# UNITED STATES PATENT AND TRADEMARK OFFICE

| APPLICATION NO.   | FILING DATE | FIRST NAMED INVENTOR | ATTORNEY DOCKET NO.               | CONFIRMATION NO. |
|---|-------------|----------------------|-----------------------------------|------------------|
| 10/698,990  | 10/31/2003  | Dan Meacham          | AIELP008                          | 8866             |

## Office Action Summary

### **DETAILED ACTION**

Figure 1 of Uriya.

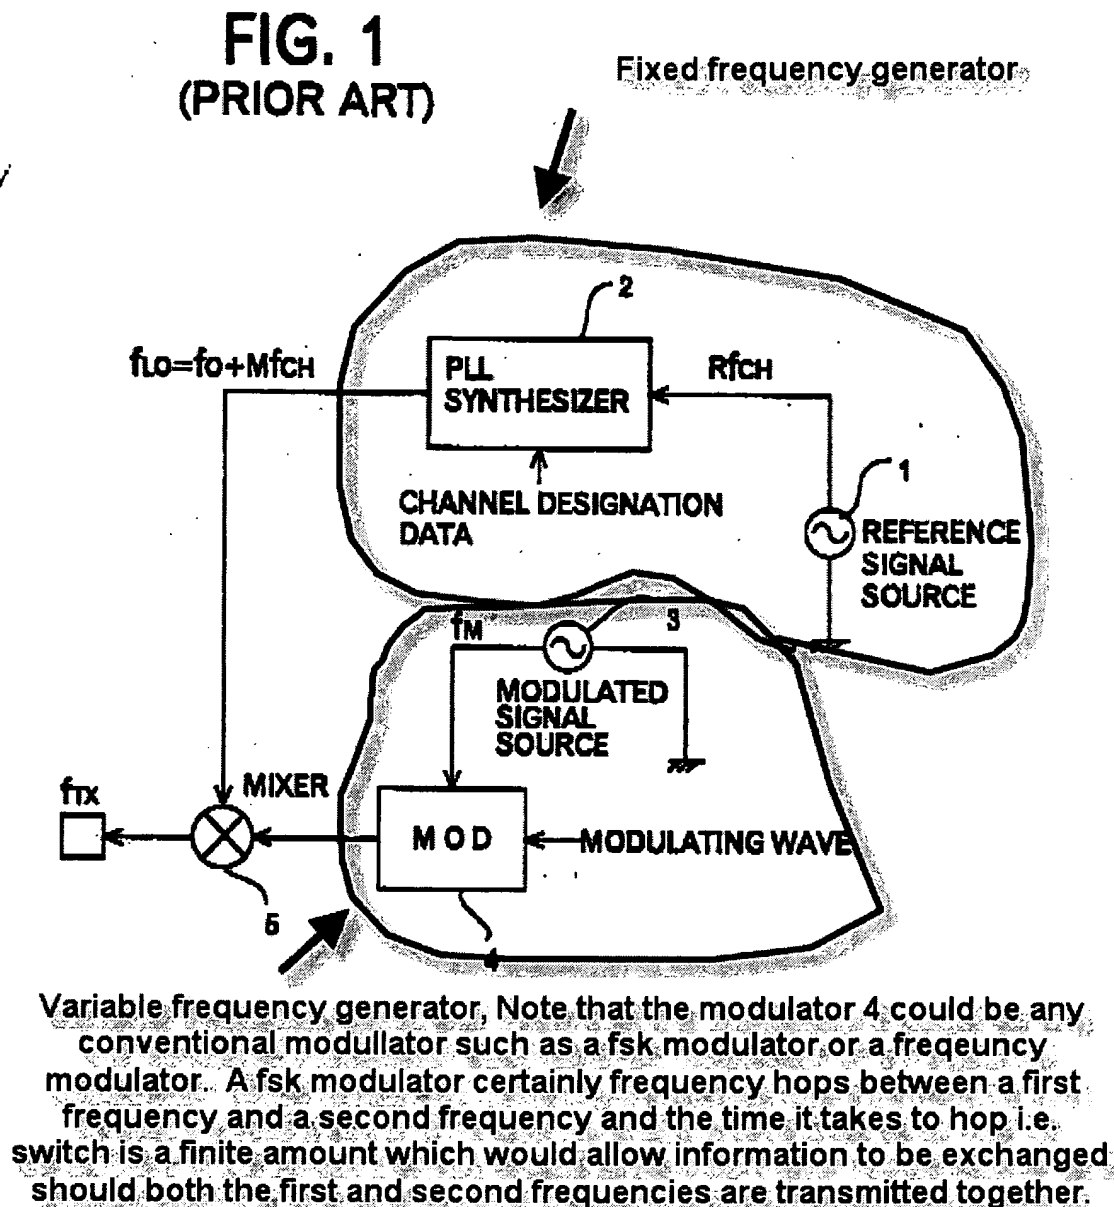
Figure 1 and the relevant text of Uriya discloses a frequency synthesizer having a fixed frequency generator formed by the PLL "2" and reference signal generator "1". (Note that when the frequency of elements "1" and "2" are selected, that this frequency generator generates a constant or fixed frequency. Also note that while this fixed frequency generator has an additional function to that disclosed by

applicant's disclosure in that the fixed frequency of Uriya is that is selectable i.e. different channels can be selected, the device "1" and "2" of Uriya may never change channels and thus would be the same fixed frequency generator as that meant by applicant.)

Figure 1 and the relevant text of Uriya also disclose a variable frequency generator in the form a modulator formed from elements "3" and "4". Uriya is not clear on the exact modulator used or employed. A FM modulator or an fsk modulator are well-known art-recognized equivalent modulators for a wireless device. Accordingly, it would have been obvious to one of ordinary skill in the art at the time the invention was made to utilized a FM modulator for Uriya because as the Uriya reference is silent on the exact structure of the modulator one of ordinary skill in the art would have been motivated to use any art-recognized equivalent modulator such as the FM or a fsk modulator.

As to the limitation that the variable signal is independent of the fixed frequency generator note the lack of any connection between these elements in Uriya. Only the outputs are combined like in applicant's disclosed invention. Also note the mixer 5 of Uriya combines the fixed frequency signal and the variable frequency signal to provide at least a first frequency and a second frequency. Also note that the carrier frequency switches or hops between these two frequencies, i.e. the invention made obvious above is in "the frequency hopping mode".

With respect to claim 2 the variable frequency generator has an output that is not connected back to the other components of the variable frequency generator (Note above the reference to Figure 1 that clearly shows this feature.).

With respect to claim 7, the modulator 4 is a fast switching component and the source 3 is a signal generator.

With respect to claim 8, the signal generator of Uriya clearly generates a plurality of signals, i.e. different frequencies. The fast switching component would be the fsk or frequency modulator.

(See Figure 1 of Uriya). The invention made obvious provides for black boxes that provide for frequency hopping, i.e. the changing of frequency from one value to another. This is the same arrangement of black boxes as shown in Figure 2A of the instant invention. Thus the examiner really believes that real solid structure needs to be claimed in order to over come the rejection at hand.
